REGION OF WATERLOO

Report: EEAC-13-016

DATE: December 17, 2013 **FILE CODE:** D04-20058/DA

SUBJECT: **PROPOSED HIGHLAND RIDGE WEST PLAN OF SUBDIVISION, CITY OF CAMBRIDGE, GILHOLM MARSH [E.S.P.A. 58] AND BARRIE'S LAKE [E.S.P.A. 57]**

From LVM, Figure 10, Seasonal High Overburden Aquifer Groundwater Contours, April 2013

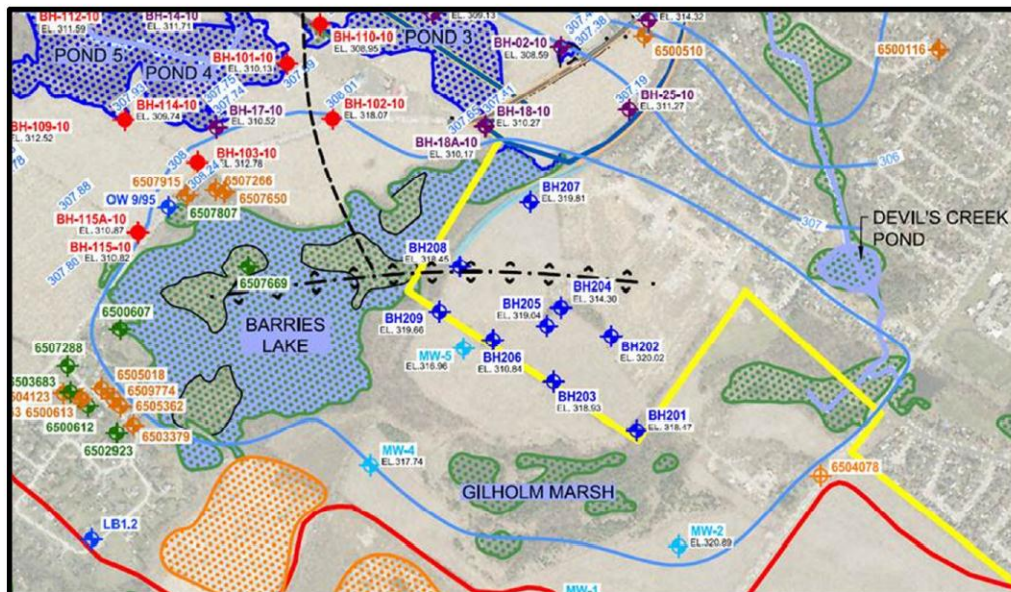
rainfall. Thus, for the majority of the year infiltration is distributed relatively uniformly across the site. In spring conditions, snowmelt and heavy rain events result in runoff being directed to low lying areas of the property. The resulting infiltration results in localized groundwater mounding, as shown both on Figure 6 of the WESA report (July 2008) and in Figure 10 of the LVM report (April 2013).

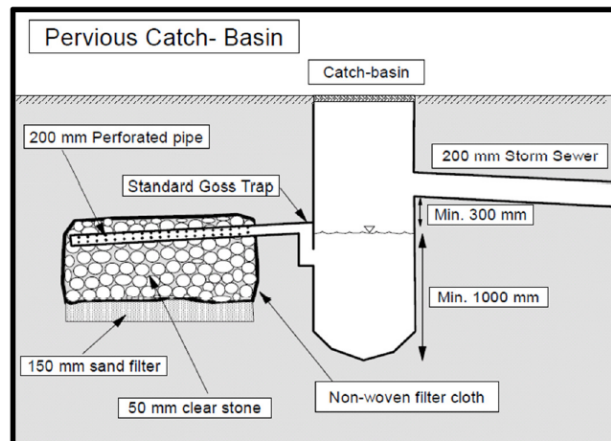
It is worth noting that recently the project team met with the City of Cambridge to discuss the location of infiltration measures on the site. The City appears is in favour of an infiltration gallery in the park block, which would collect roof runoff from all the lots backing onto the park and infiltrate in one location such as near the intersection of Salisbury Avenue and Street One, very close to the location of the existing kettle. The collection capacity of this facility would be sized for surface drainage from rear half of roofs and backyards. Runoff would be directed to pervious catchbasins tied to the infiltration gallery. In this way, runoff can both be pre-treated and cooled prior to infiltration.

The park block would be graded so that runoff in larger storm events would be directed to this infiltration gallery to mimic existing conditions. The end result is that a point infiltration source from about 1.6 hectares of contributing area would assist not only in ensuring the pre-development infiltration rate is maintained, but in ensuring that the groundwater mounding currently taking place would continue. As a result of these proposed infiltration measures, the infiltration volume and location of the same across the site will closely mimic existing conditions. In addition to this suggestion, the City of Cambridge has been presented with other options that could supplement infiltration spatially across the site.
